#### **ADDENDUM NO. 1**

Date: April 13, 2016

**Project:** AC Paving/Concrete Replacement at Ethel Phillips ES

#### **ITEM # 1.5** Sheet A100 – Site Demolition Plan:

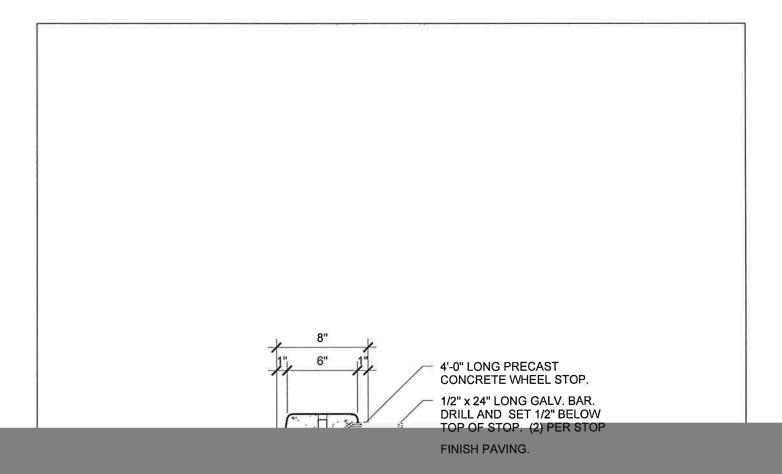
- A. Change Note .13 to read: "CONTRACTOR SHALL BE RESPONSIBLE TO SALVAGE, REMOVE, AND RELOCATE STORAGE SHEDS DURING CONSTRUCTION, AND REINSTALL SHEDS IN THE SAME LOCATION PER DISTRICT REQUEST AFTER AC PAVING IS

- B. At the 12'-0" tall fence immediately next to the existing adjacent building, at the East end of the site, change the three Keyed Notes indicating .07 to indicate Keyed Note .19. This portion of the fence will be demolished completely, and will not be reinstalled. The 12'-0" tall fence should return and terminate at the neighboring building. See revised Sheet ADD-1 A101 for additional information.
